**Response to Comments
on
EPA Draft 2020 Permit Modification to the 2016 Reissued RCRA Permit and
Associated Statement of Basis for EPA’s Remedial Action for the “Rest of River”
Portion of the Housatonic River**

GE-Pittsfield/Housatonic River Site

December 2020

U.S. Environmental Protection Agency
Region 1 (EPA New England)

ALLENDALE SCHOOL PCB
AIR SAMPLING RESULTS

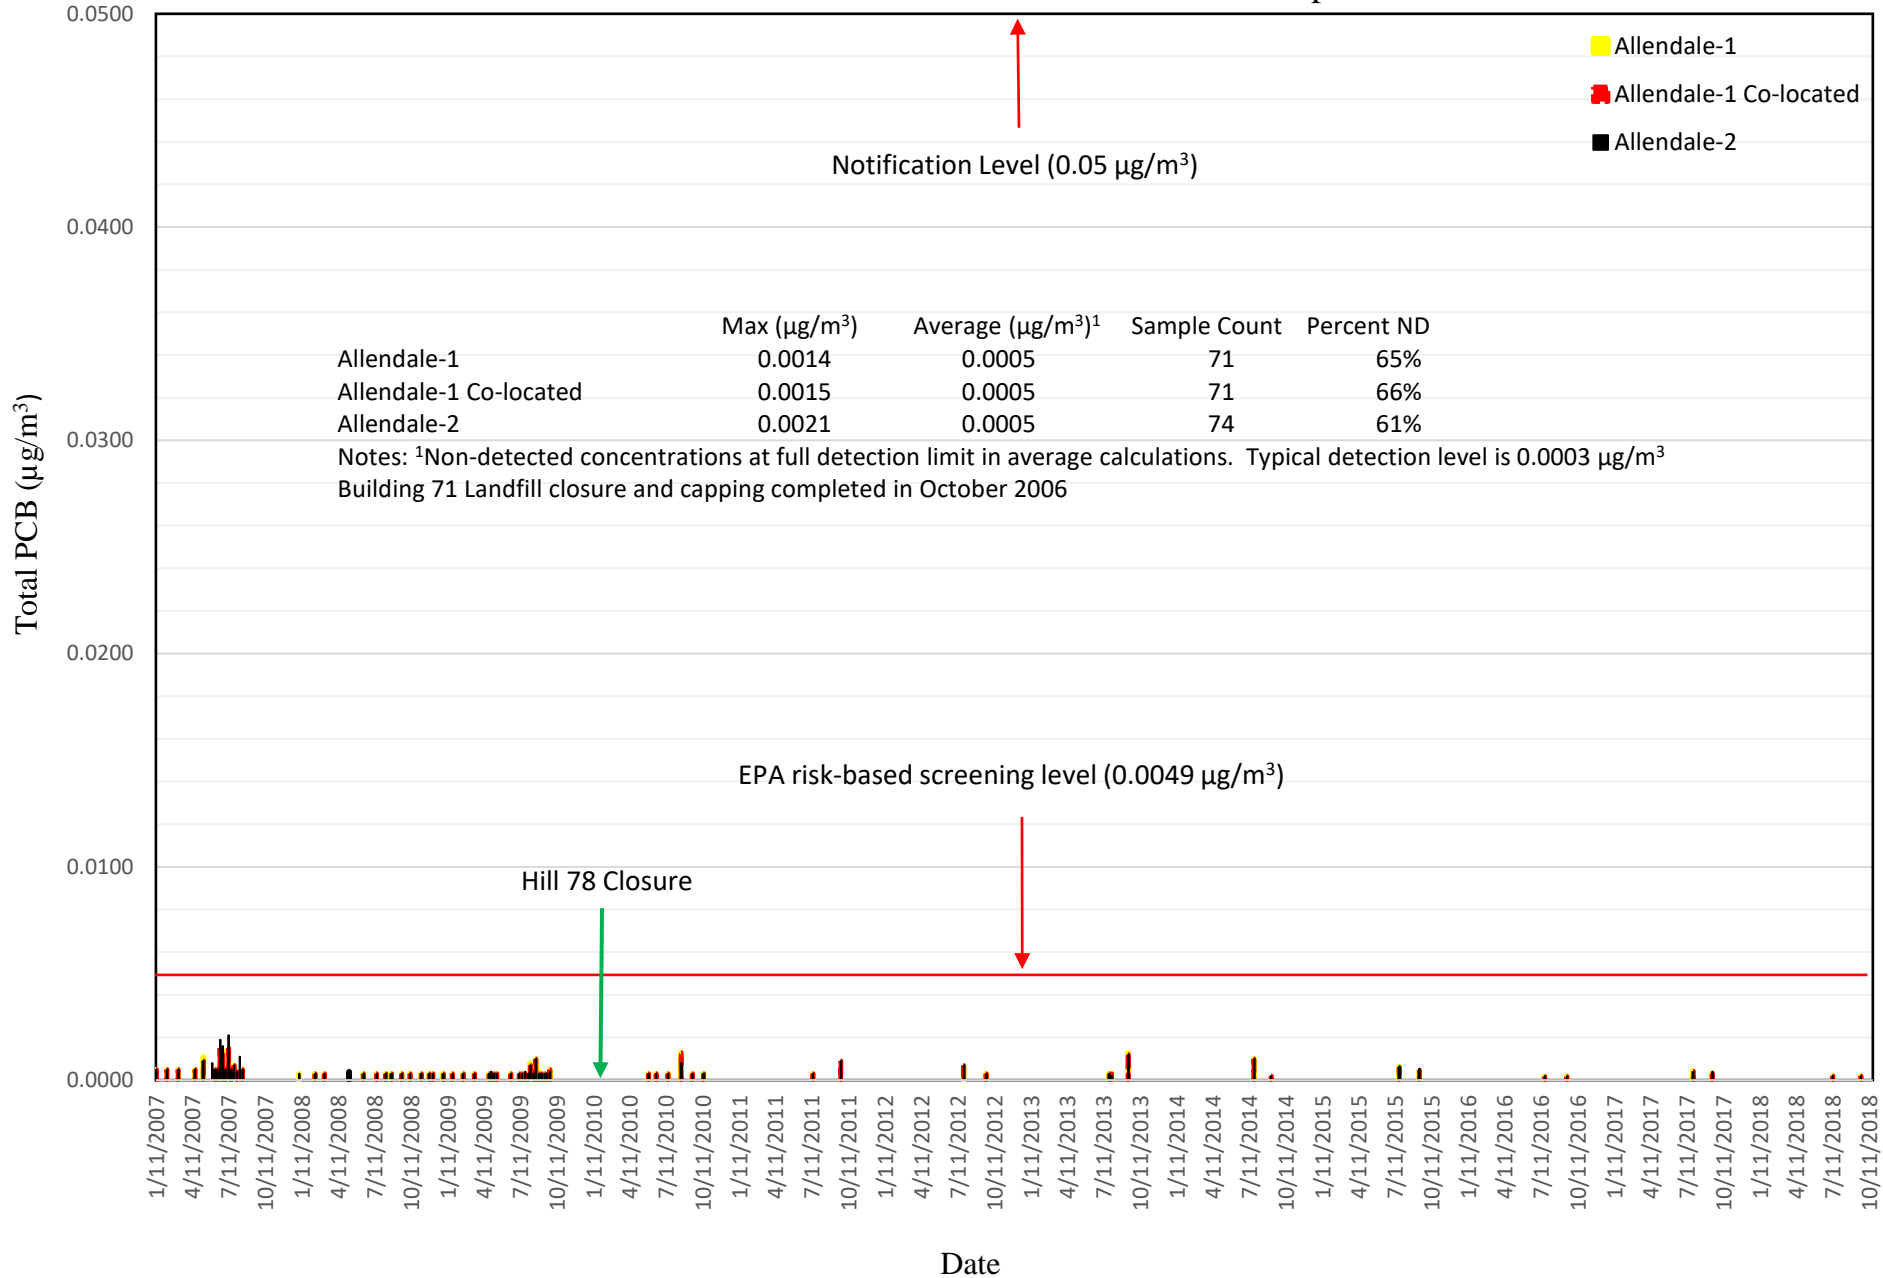
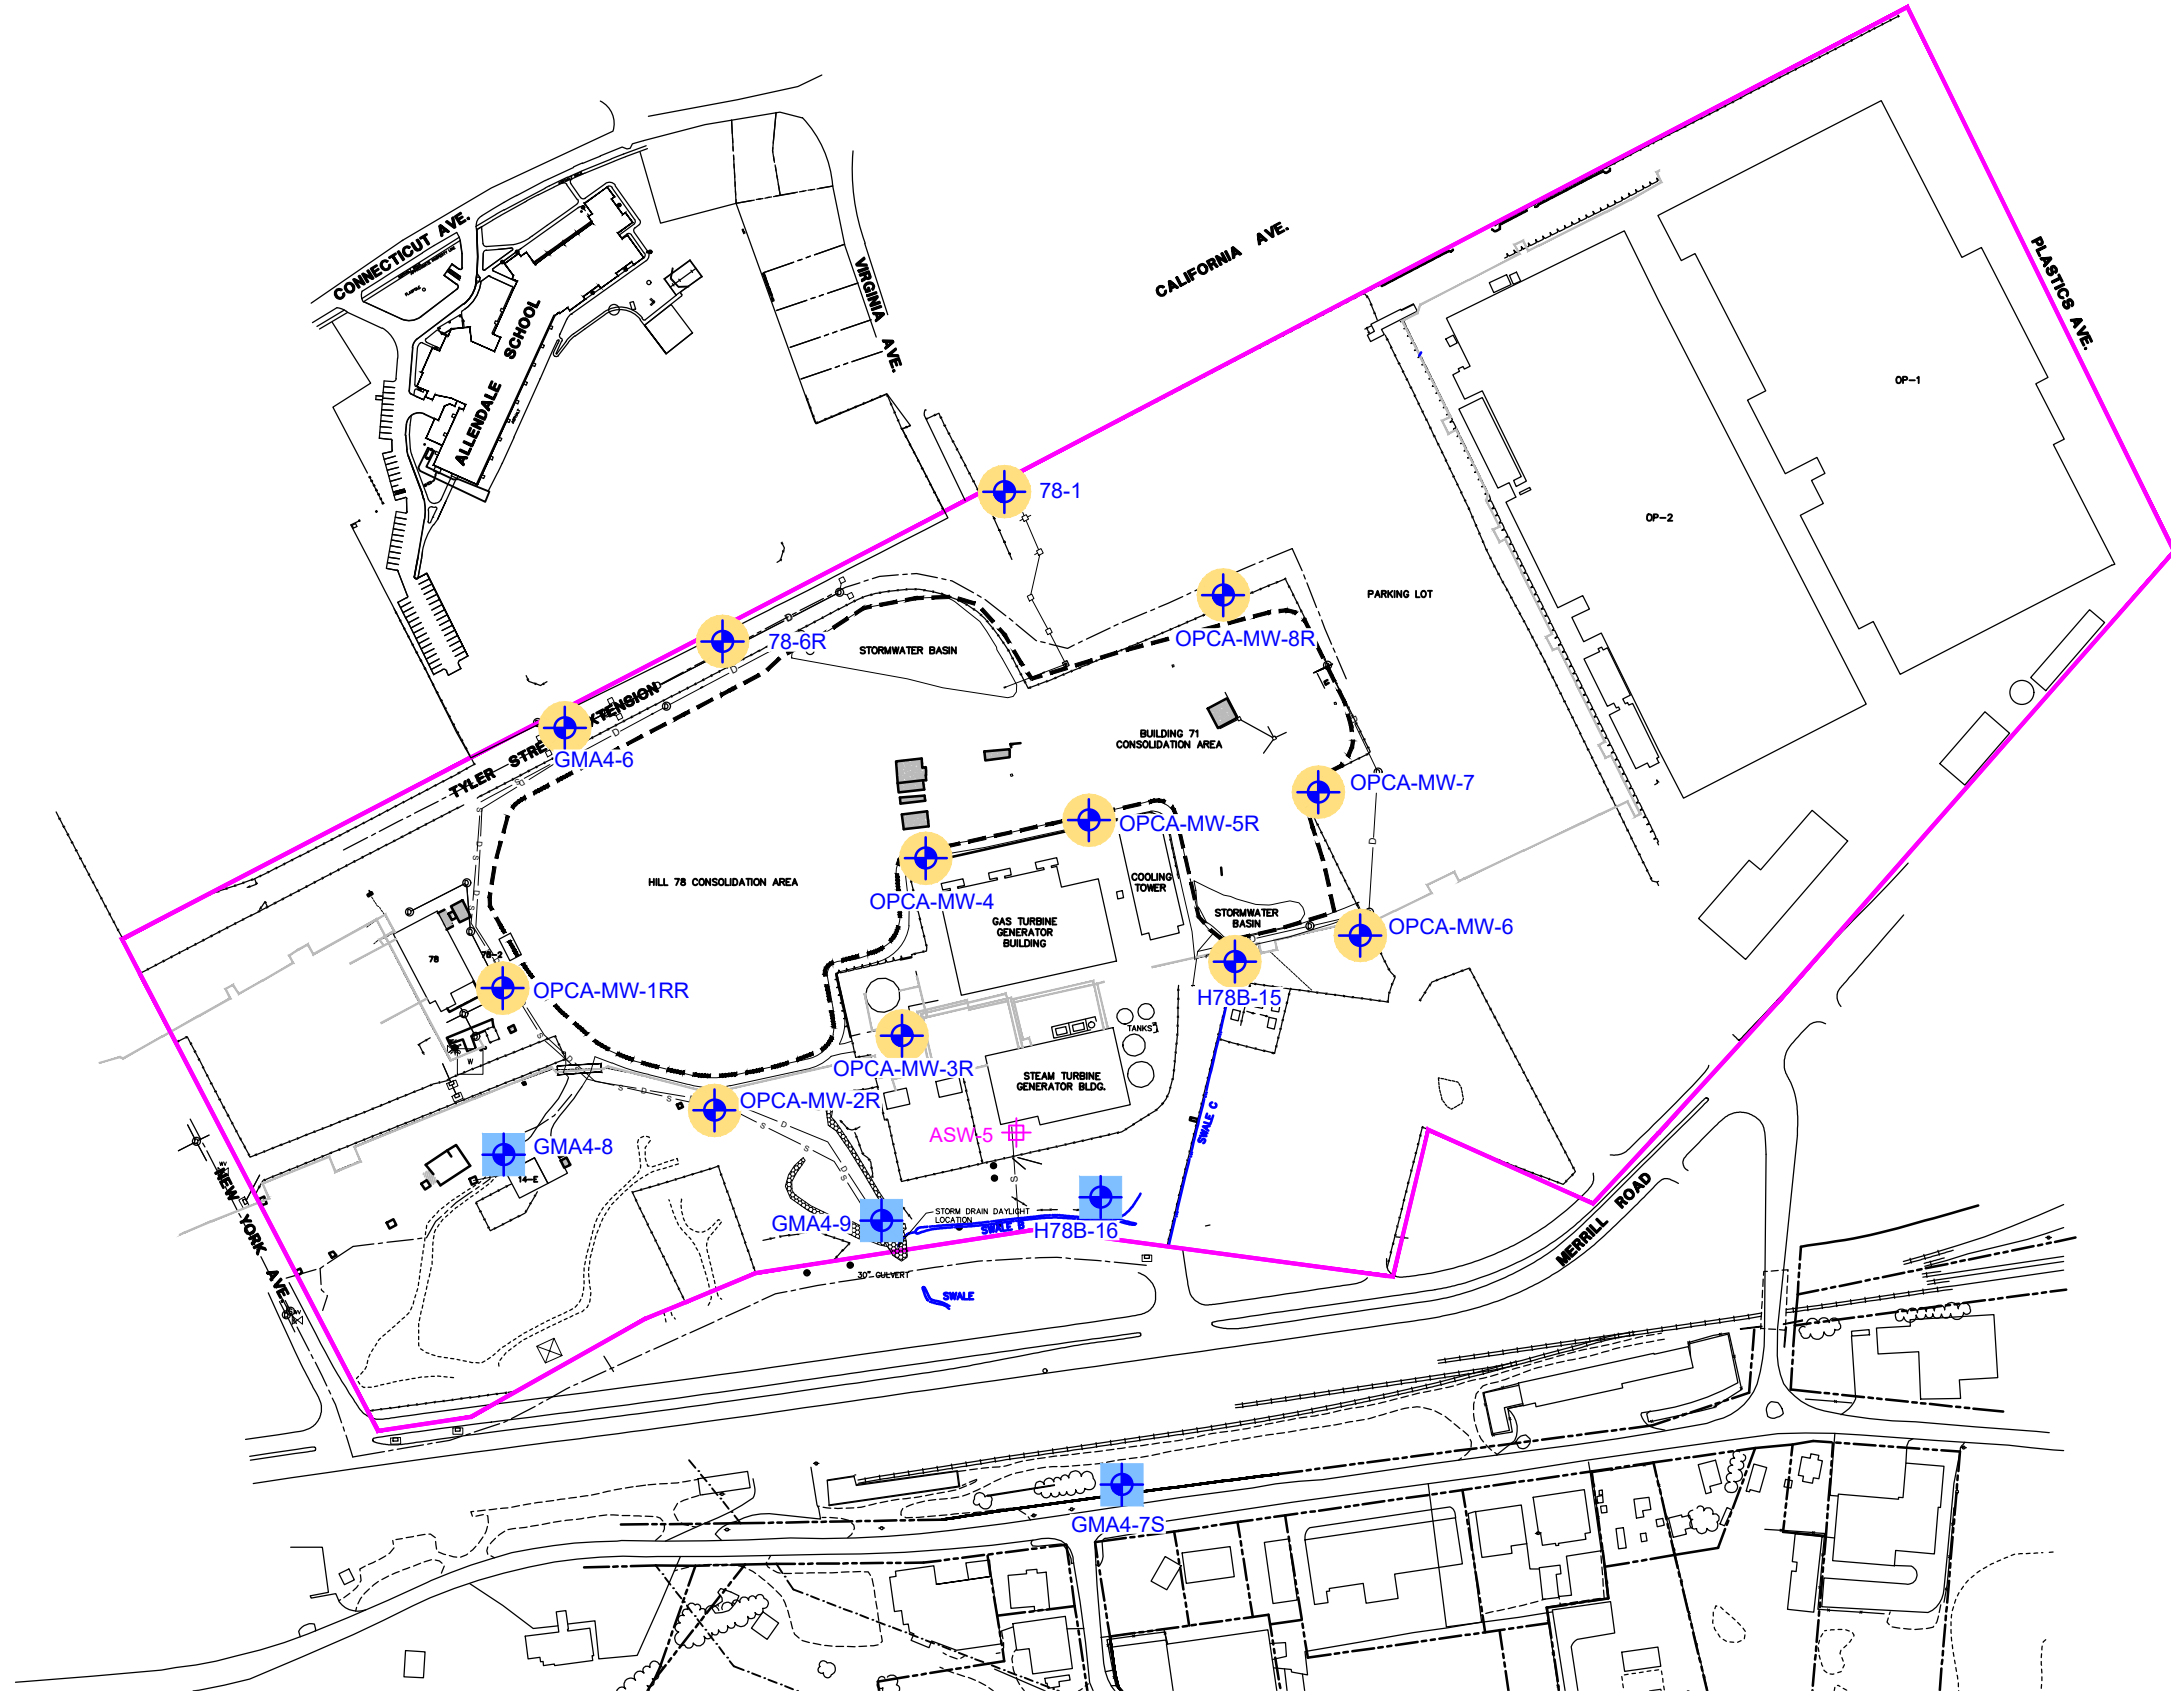
Comment II.A.3: Several commenters expressed concerns that the proposed UDF is similar to the landfills/OPCAs constructed in Pittsfield as part of the Consent Decree and that in the commenters' view, the landfills/OPCAs are leaking or are otherwise not safe.

From 2007 through 2018, the average PCB air concentration was 100 times below the site-specific notification/action level and approximately 10 times below EPA's national screening level. Figure 4. The data from 2019 and 2020 are, on average, lower than the $0.0005 \mu\text{g}/\text{m}^3$ average concentration from 2007 through 2018. Tables 1 and 2.

**FIGURE 7
SURFACE WATER ELEVATIONS
AND WATERSHED SUBBASINS**

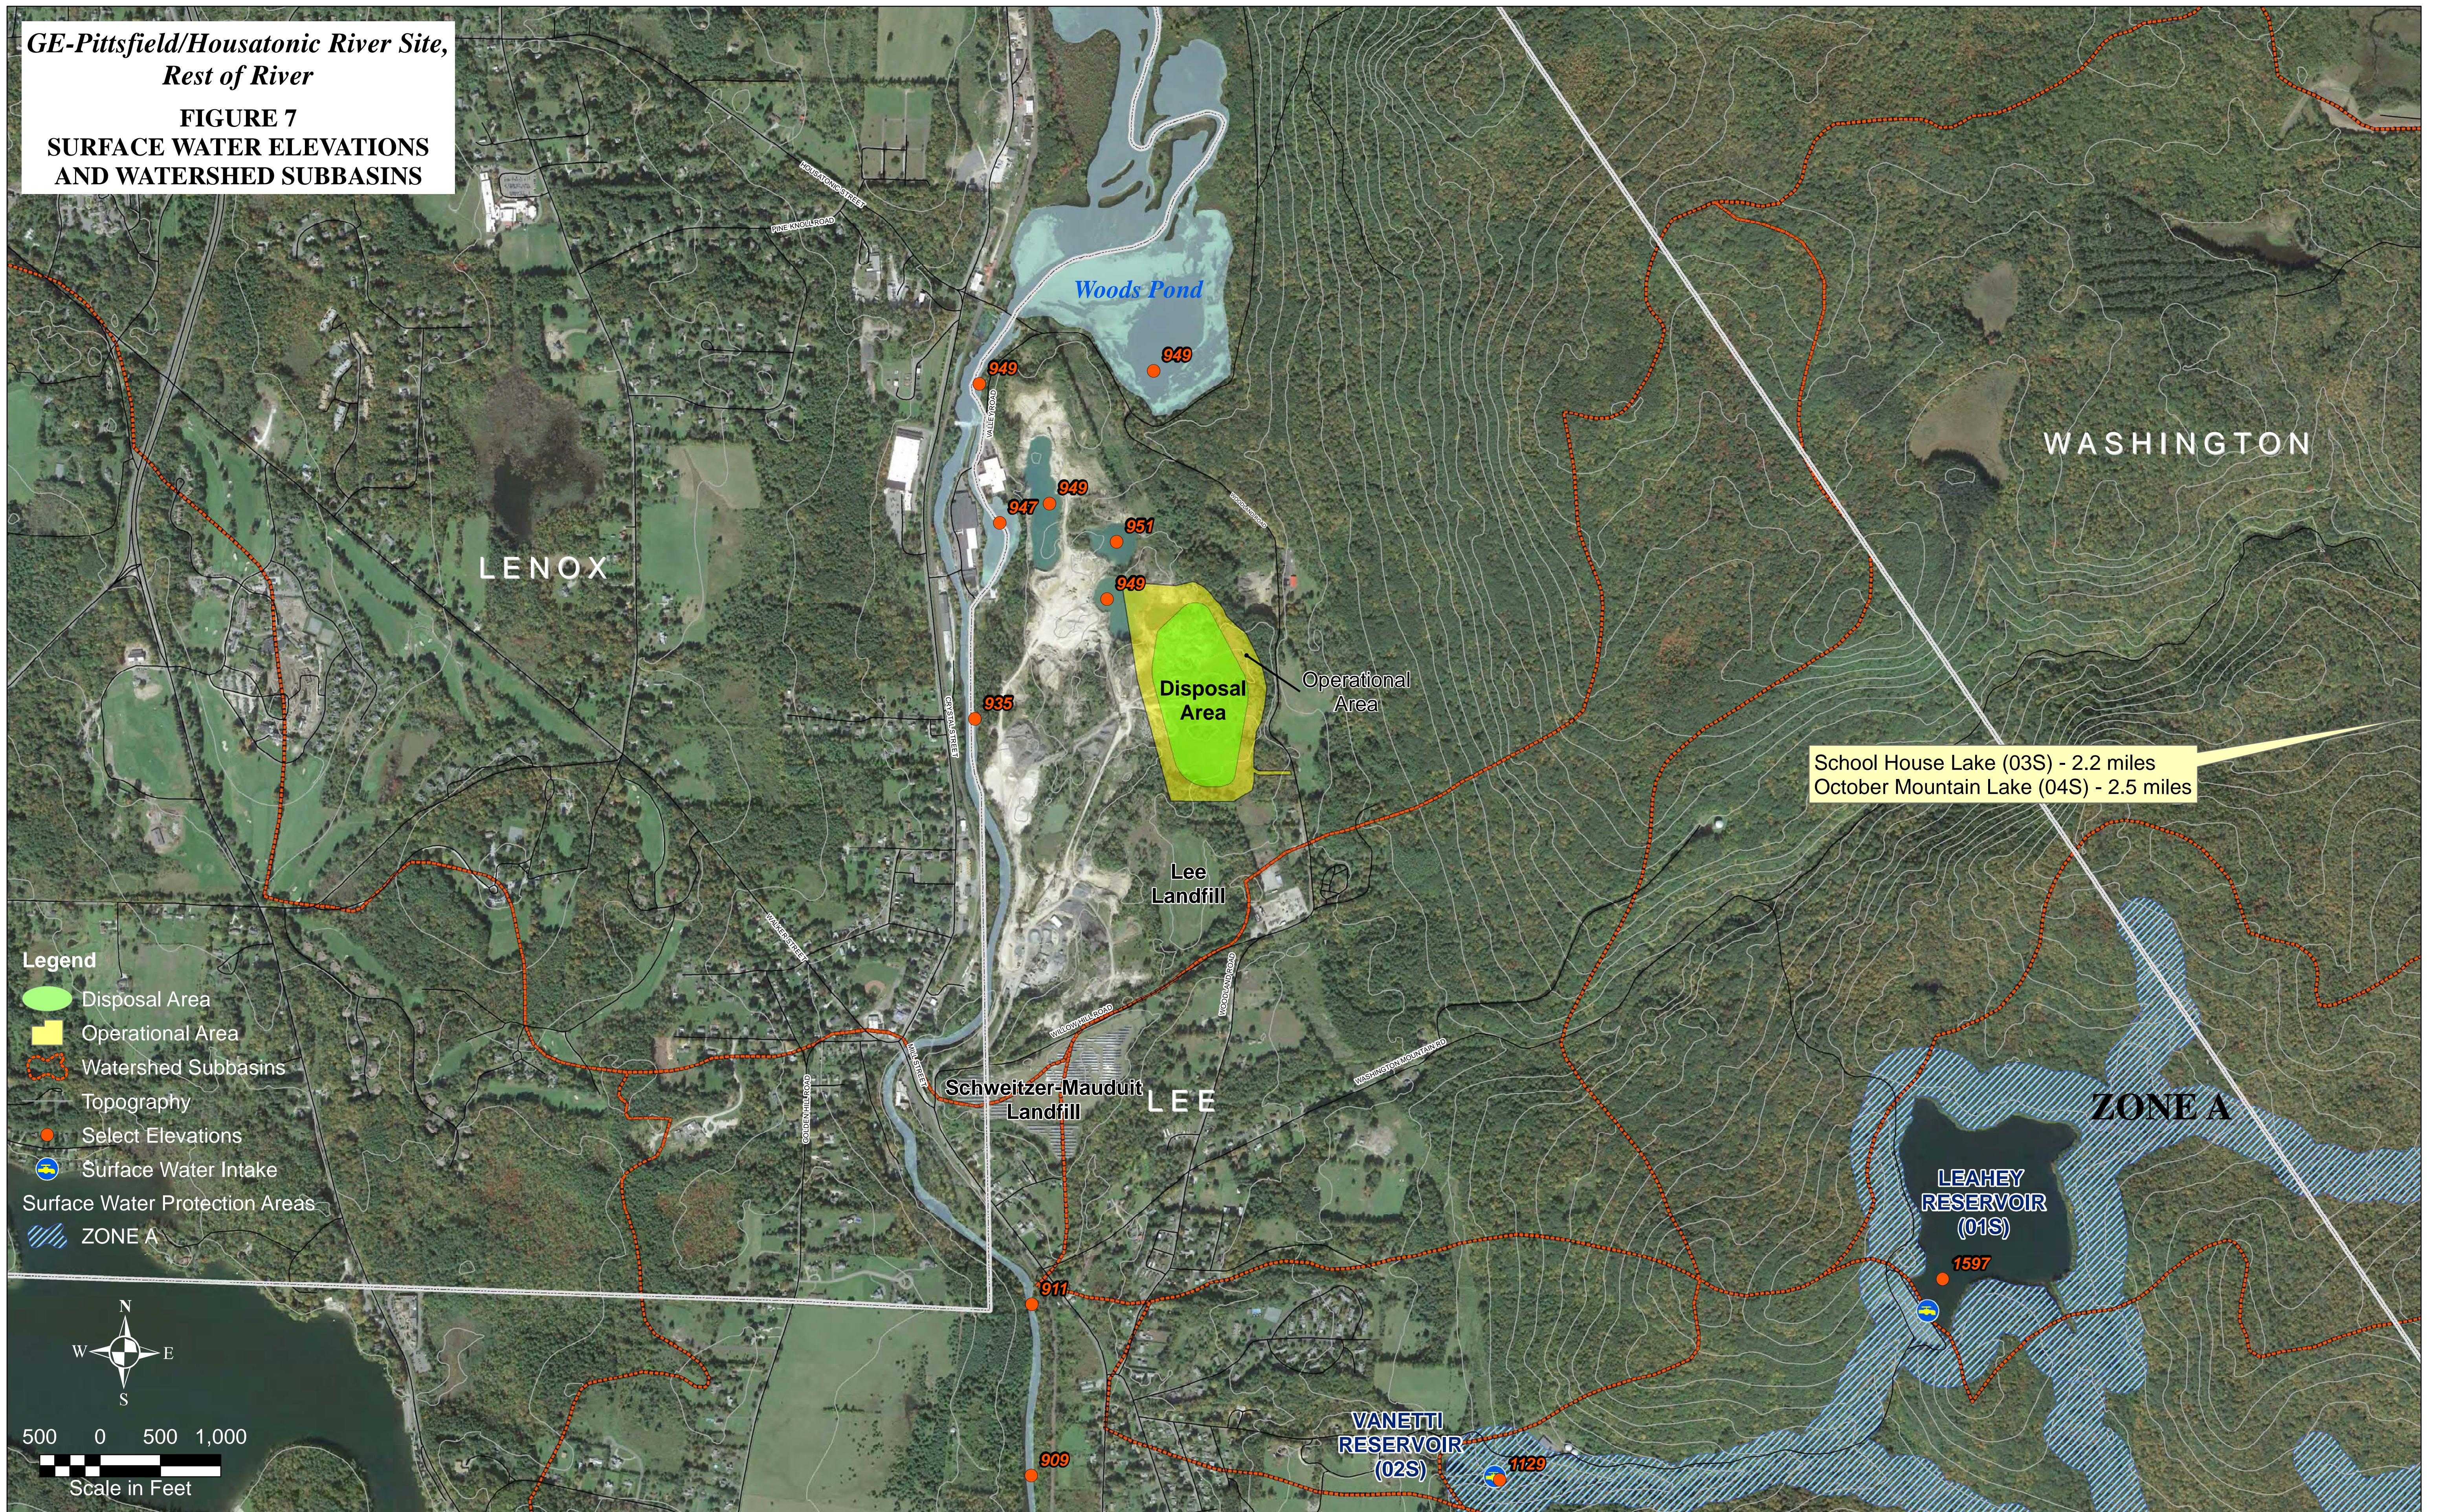
Comment II.A.5: Several commenters expressed concerns about impacts to local water supplies should a release occur. A number of commenters questioned the provisions for abandonment of

reservoirs. 2018 Post-Closure Environmental Monitoring Report, Schweitzer-Mauduit International, Inc. Willow Hill Road Landfill, C.T. Male Associates to DEP, June 11, 2018; CDM figure titled “Town of Lee Sanitary Landfill, Bedrock and Overburden Contours, January 30, 1995.” Figure 9. In addition, based on surface water elevations, the expected groundwater flow is generally east to west—from the UDF towards the Housatonic River, and similarly, from the Town of Lee reservoirs westerly towards the River. Figure 7.
